Site Layout Modifications to Support the Lockhart Substation

# TRANSMISSION INTERCONNECTION REVISED SITE LOCATION

## MOJAVE SOLAR

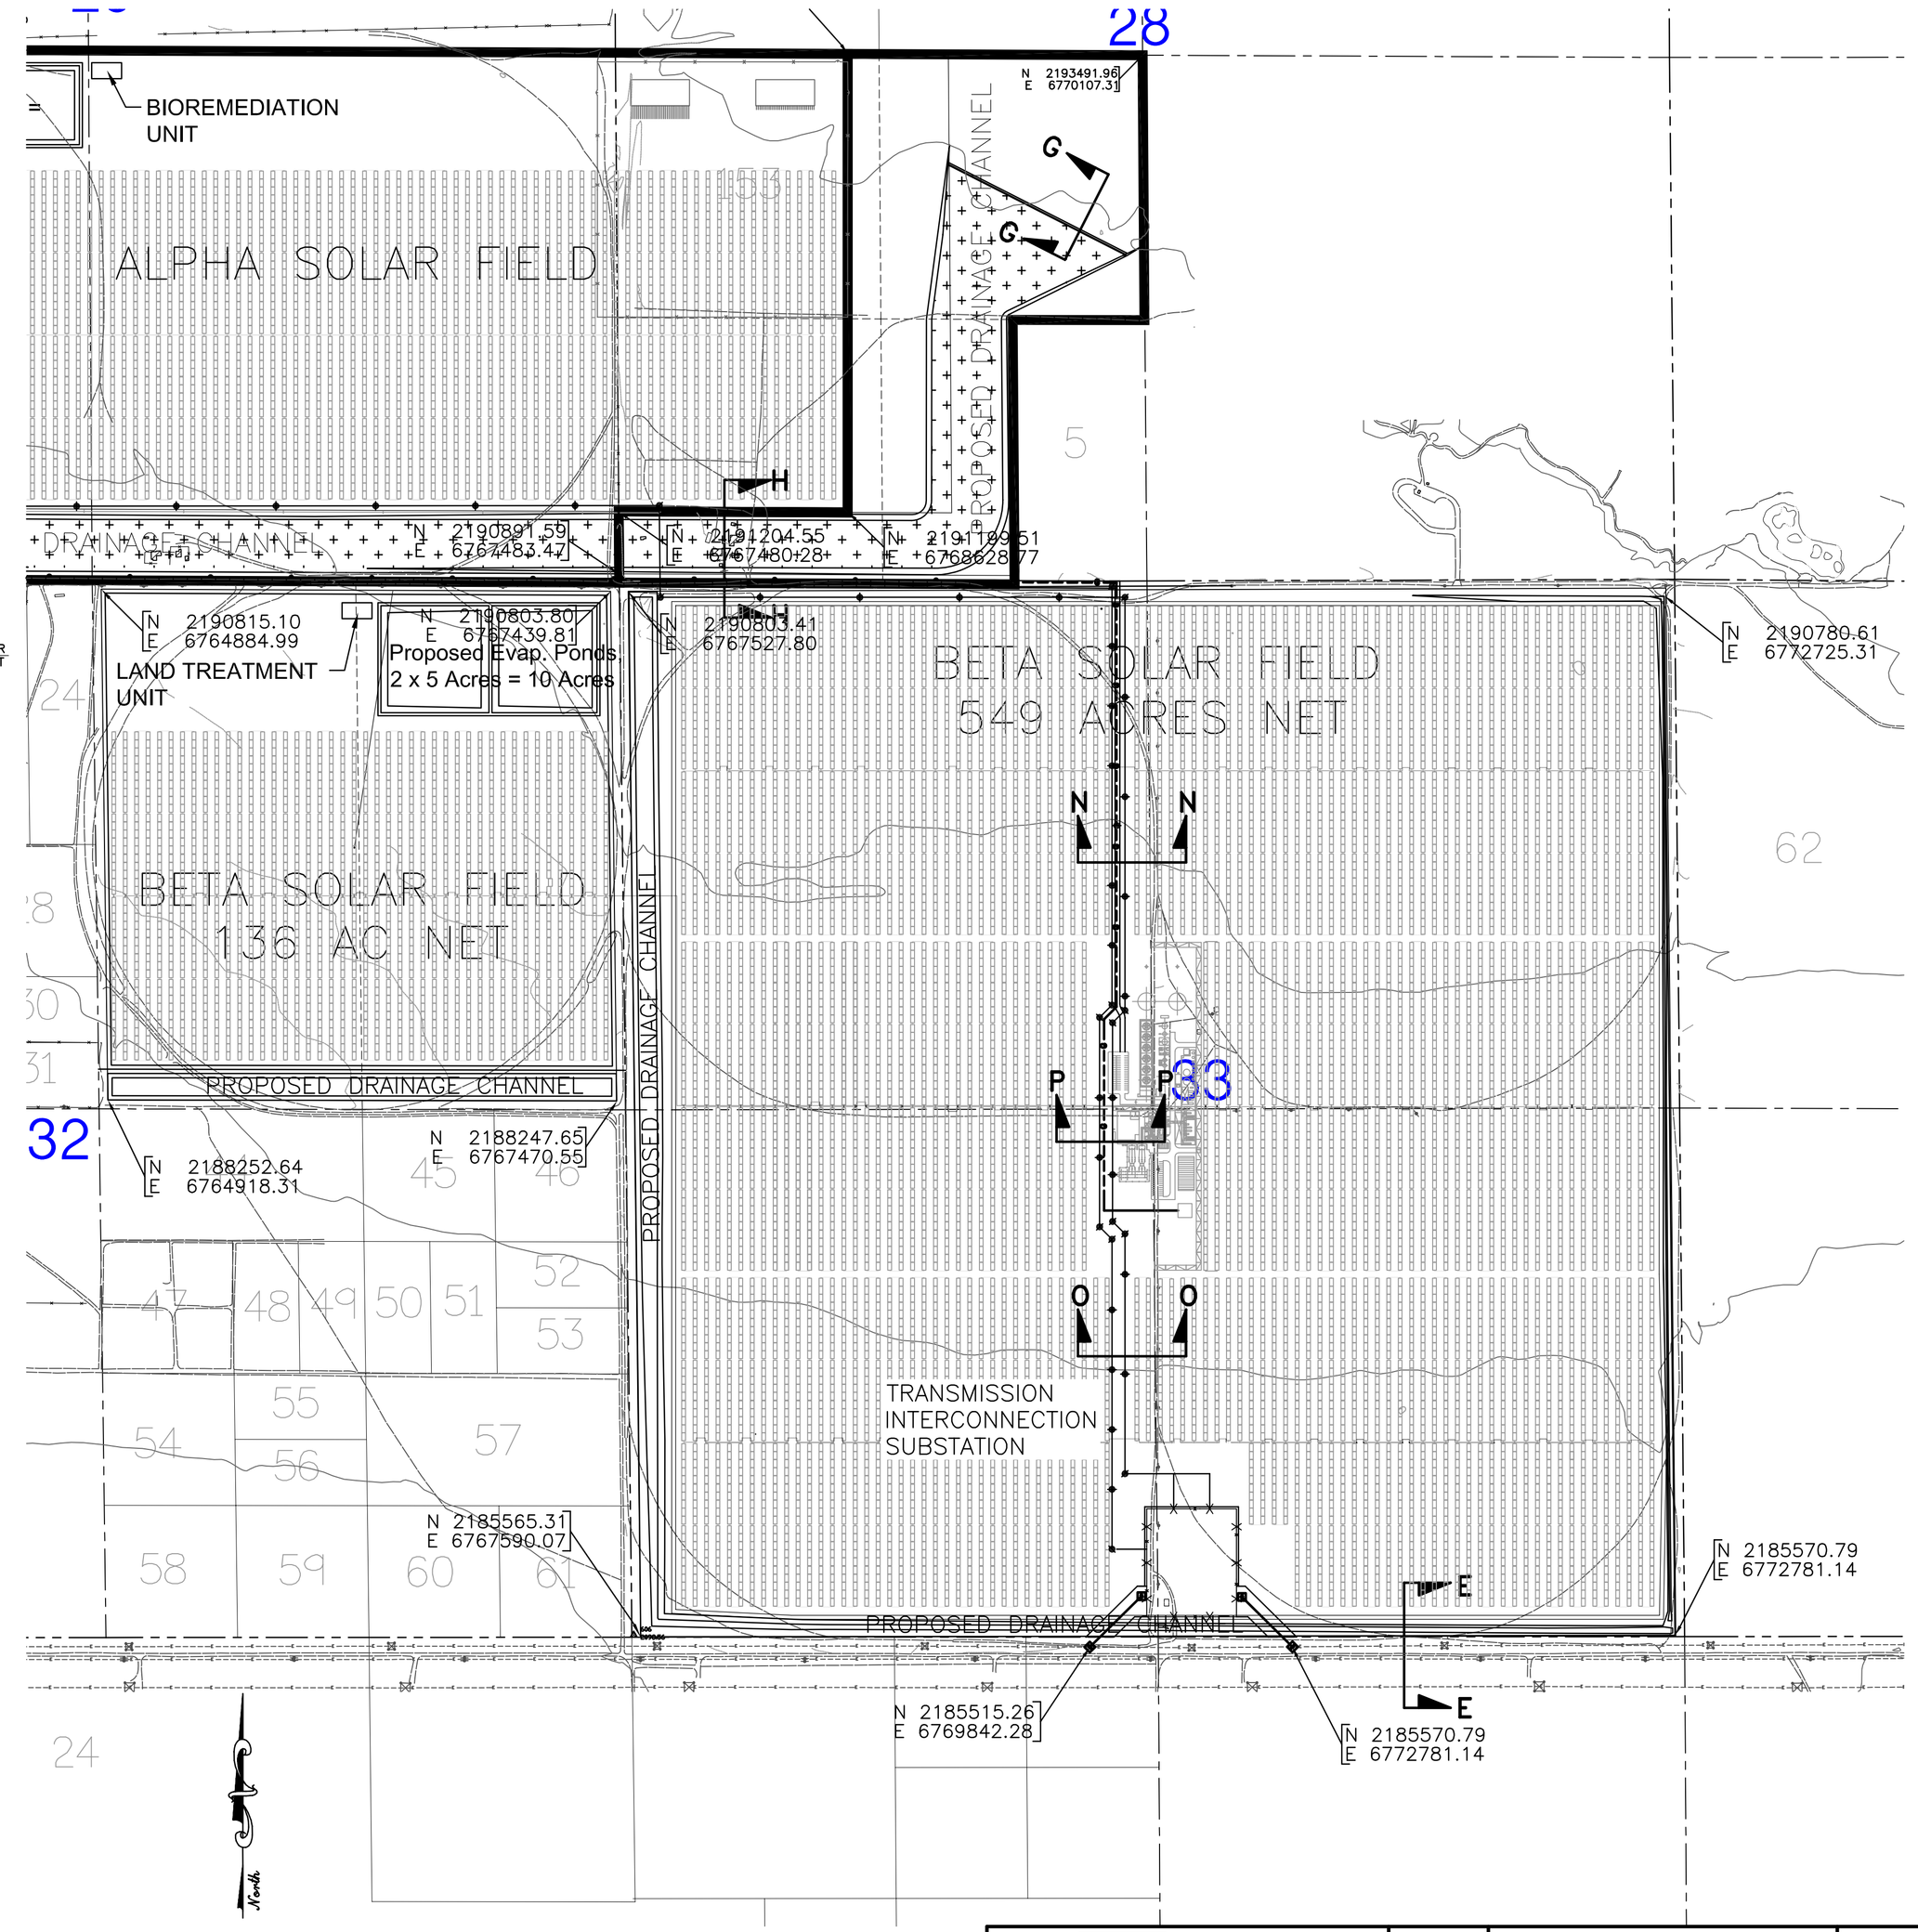
1. The Lockhart substation is shown directly south of the Beta Power Island to allow for the SCE-agreed location for loop-in to the existing transmission line while accommodating a better location of the onsite transmission line.

2. The onsite transmission line from the Beta Power Island now runs directly south to the first point of interconnection at the Lockhart substation, no longer running along the southern boundary.

3. The onsite transmission line from the Alpha Power Island now runs across the northern portion of Beta and then directly south to the Lockhart substation past the Beta Power Island. This moves the transmission line from the western boundary of the Beta Site to the center of the Beta site.

4. A 12-kV line for station power from the existing 12-kV line that runs across the northern boundary of the Beta Site is included. This is to supply independent station power to the Lockhart substation at SCE's request. This is a realignment of a ROW that exists on the site already to accommodate the location of the proposed power plan site plan.

5. The drainage channel along the southern boundary of the Beta site is moved south to accommodate a ROW to the Lockhart substation from the east at SCE's request.
